# UNITED STATES PATENT AND TRADEMARK OFFICE

APPLICATION NO.	FILING DATE	FIRST NAMED INVENTOR	ATTORNEY DOCKET NO.	CONFIRMATION NO.
10/798,779	03/12/2004	David G. Filippi	COLME-0004	5631

<p align="center"><b>Office Action Summary</b></p>	<p><b>Application No.</b></p> <p align="center">10/798,779</p>	<p><b>Applicant(s)</b></p> <p align="center">FILIPPI, DAVID G.</p>	
	<p><b>Examiner</b></p> <p align="center">Christine T. Cajilig</p>	<p><b>Art Unit</b></p> <p align="center">3637</p>

## **DETAILED ACTION**

Doussot et al. (U.S. Patent No. 5,426,832)

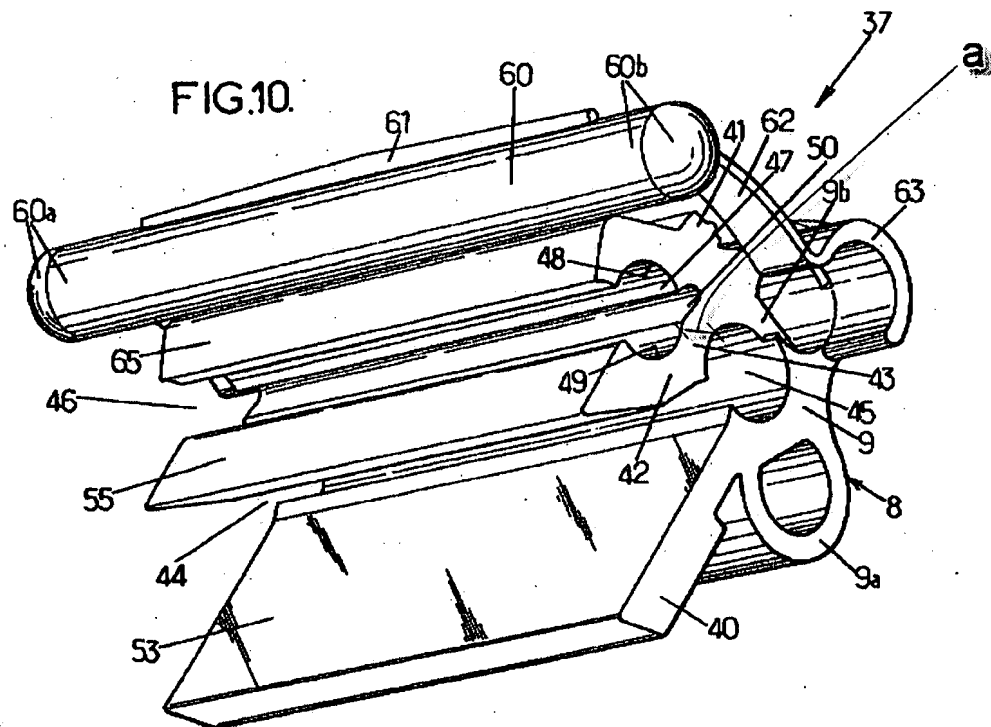
Regarding claim 43, Elko et al. discloses a gutter-cover system as discussed above but does not disclose a gutter-cover system further including a bending slot in said body portion, said bending slot being located above said second throat so that said hinge is between said second throat and said bending slot, said hinge having a width whereby a force applied to said bending slot moves said locking lever about said hinge so that said third jaw is brought into locking engagement with said wall of said gutter. However, Doussot et al. in Figures 10 and 13 discloses a fixing clip including a bending slot (46) in a body portion (37), said bending slot (46) being located above a second throat (45) so that a hinge (43) is between said second throat (45) and said bending slot (46) and having a width (a) whereby a force applied to said bending slot (46) moves a locking lever (55) about said hinge (43) so that a third jaw (57) is brought into locking engagement with a rod (4). Elko et al. and Doussot et al. are analogous art because they are pertinent in the problem of securing a member via a clip. Therefore, it would have been obvious to a person having ordinary skill in the arts at the time of the applicant's invention to modify the clip of Elko et al. to include a bending slot in said body portion, said bending slot being located above said second throat so that said hinge is between said second throat and said bending slot and having a width (D3)

whereby a force applied to said bending slot moves said locking lever about said hinge so that said third jaw is brought into locking engagement with said wall of said gutter as taught by Doussot et al. to further clamp down on an object that needs to be secured, in this case, the gutter wall (Col 10, Ln 3-17).
